UNITED STATES PATENT AND TRADEMARK OFFICE

APPLICATION NO.	FILING DATE	FIRST NAMED INVENTOR	ATTORNEY DOCKET NO.	CONFIRMATION NO.
10/727,760	12/03/2003	Jim Mali	ARTCP050	7568
25920	7590	04/14/2005	EXAMINER	
MARTINE PENILLA & GENCARELLA, LLP 710 LAKEWAY DRIVE SUITE 200 SUNNYVALE, CA 94085			NGUYEN, THINH T	
			ART UNIT	PAPER NUMBER
			2818

Office Action Summary

DETAILED OFFICE ACTION

FIG. 4

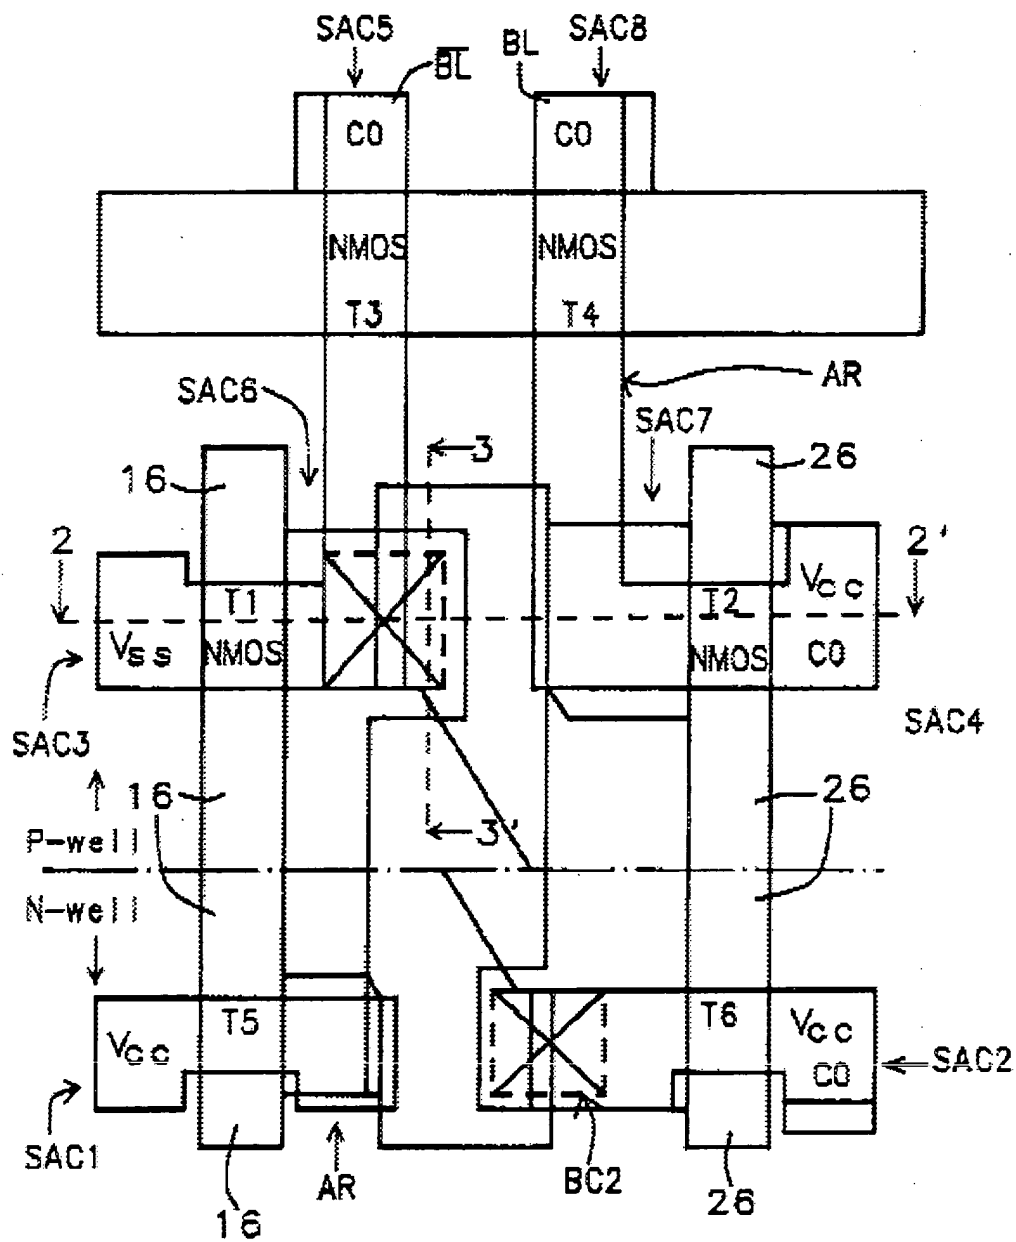
Applicant discloses in paragraph [0012] that the n-type transistor is fabricated on an n-type substrate and the p-type transistor is fabricated on a p type substrate. This disclosure is different from a conventional well known structure as shown in fig 4 in US patent 5,843,816 by Liaw that shows that N-type is fabricate on P-well (or P substrate) and P-type is fabricate on N-well (or N-substrate); also see fig 4-2 (a) page 137 From Silicon Processing for the VLSI Era (volume 3) by Stanley Wolf published by Lattice press (1995) attached to the PTO-892 of this Office Action.

Can the Applicants give evidence of prior art that have a P-type transistor (a MOSFET transistor that the source and drain are P-type) that have a P-channel built on a P substrate or a N-type transistor (a MOSFET transistor that the source and drain are N-type) that have a N-channel built on a N substrate with a n-channel since the Examiner is not aware of those structure.

Correction or clarification is required.

FIG. 19

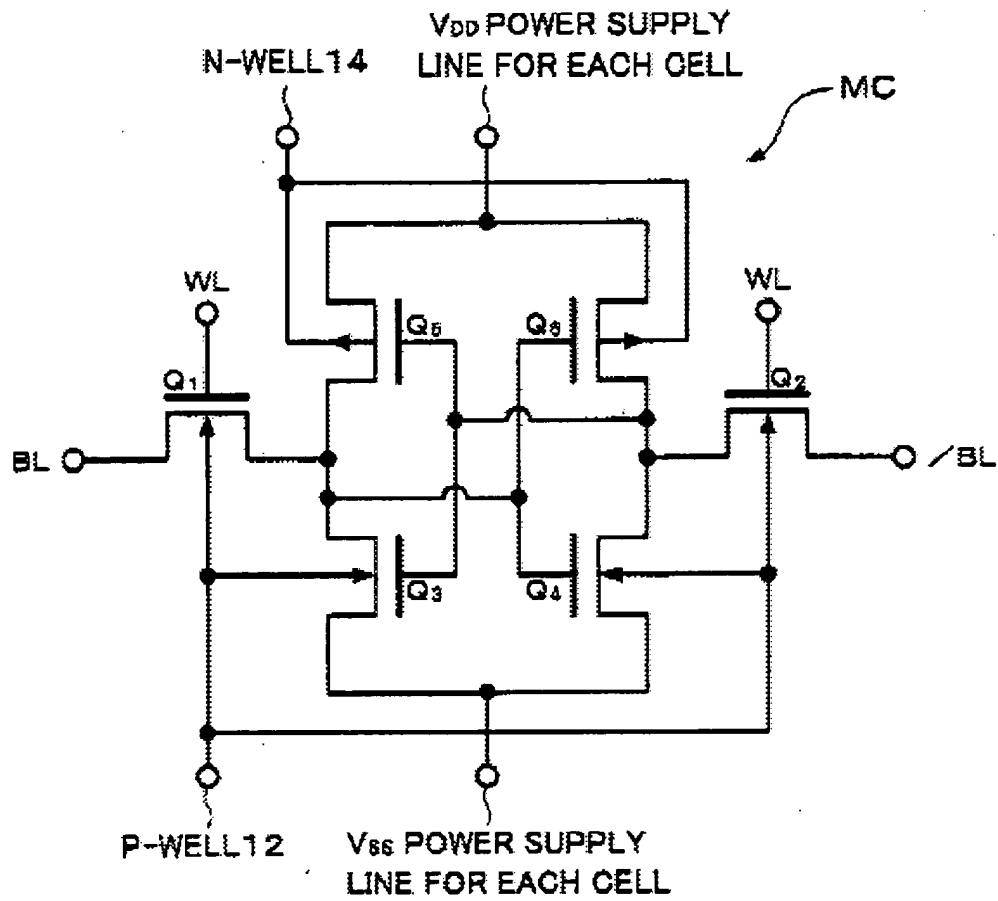
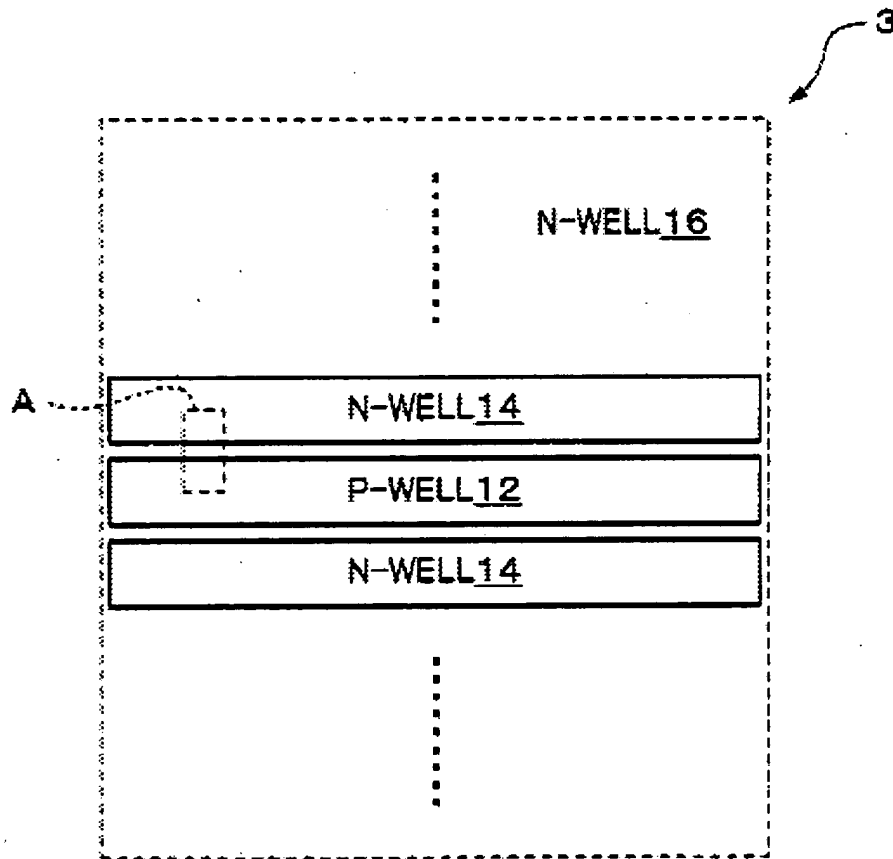
Kumagai (the abstract , fig 17, fig 19) discloses a core cell (a SRAM cell) fabricated upon a substrate of three columns of substrate material, the three columns of substrate material comprising a first n-type column, a first p-type column and a second n-type column, the p-type column being positioned between the first and second n-type columns and a random access memory comprised of at least a plurality of core cells, a core cell, comprising: first n-type substrate; first p-type substrate; and second n-type substrate, the first and second n-type substrates being positioned on opposite sides of the first p-type substrate.

Kumagai disclose (in fig 19) a core cell wherein the substrates have rectangular shapes.

FIG. 3C

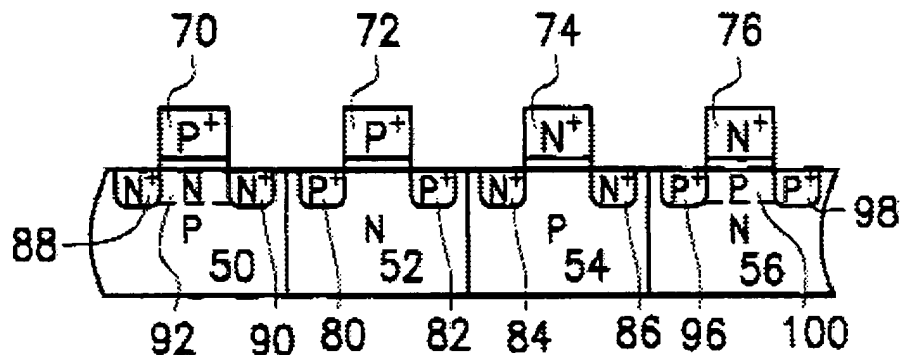
Wang disclose a first and second n-type (layer 52 and 56 in fig 3C with a p type (layer 54) in middle (fig 3C) and his structure are intended for use in SRAM fabrication.(column 1 line 20)
